Access Compliance Report

Public Rights-of-Way

(Curb Ramps)

Intersection ID: 18769	Main Street: BARCLAY_DOWNS_DR	Cross Street: RUNNYMEDE_LN	Location: SE
ADA ID: C98FFF4E2107	Ramp Type: Perp	Initial Pass/Fail: Fail	Overall Compliance: No
			Severity Score: 13.75

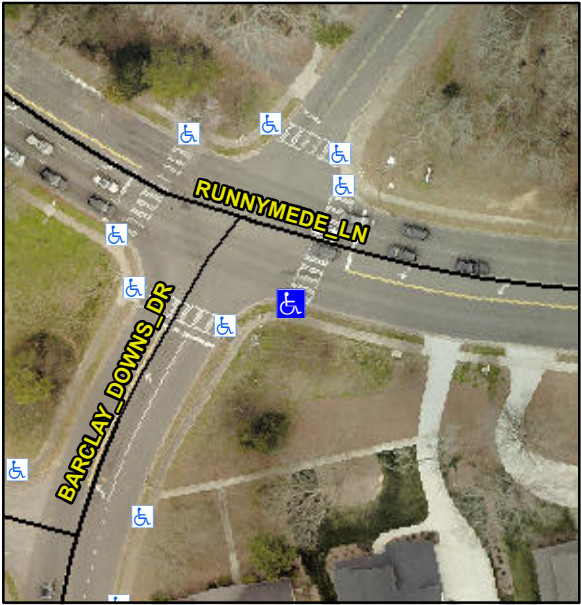
Codes/Mitigation Info/Possible Solution			Field Measurements/Component Compliance		
	Possible Solutions:		Compliance	Description	Data
	Remove & Replace Entire Ramp.		No	Ramp Length (in)	50.0
			Yes	Ramp Width (in)	48.0
			N/A	Flare Type LT	N/A
			N/A	Flare Slope LT (%)	N/A
			N/A	Flare Traversable LT?	N/A
			N/A	Landing Length (in)	N/A
			N/A	Landing Width (in)	N/A
			N/A	Landing Slope (%)	N/A
			N/A	Landing X Slope (%)	N/A
Surveyor Notes: N/A PROW/ADA: Not Found, R304.2.2			N/A	Flare Type RT	N/A
			N/A	Flare Slope RT (%)	N/A
			N/A	Flare Traversable RT?	N/A
			N/A	DWS Provided?	N/A
			N/A	DWS Contrast?	N/A
			N/A	DWS Length (in)	N/A
			N/A	DWS Full Width?	N/A
			N/A	DWS Offset (in)	N/A
			N/A	Shared Landing?	N/A
			N/A	Gutter Ponding?	N/A
			N/A	Gutter Lip Ht (in)	N/A
			N/A	Painted X Walk1?	Yes
				X Walk 1 Direction	To NE
			N/A	X Walk 1 Width (in)	135.0
				X Walk 1 Slope (%)	7.3
				X Walk 1 X Slope (%)	4.7
			N/A	Ramp inside XWalk1?	Yes

N/A	Road Slope (%)	N/A
			N/A	Road X Slope (%)	N/A
			N/A	Any Obstructions?	N/A
				Obstruction Type	
			N/A		
			N/A		
			N/A		
			N/A		
			N/A		
			N/A		
			N/A		
			N/A		
			N/A		
Total Cost:		\$ 1850.00			
			N/A		
			Yes	Surface Condition? (G/P)	Good
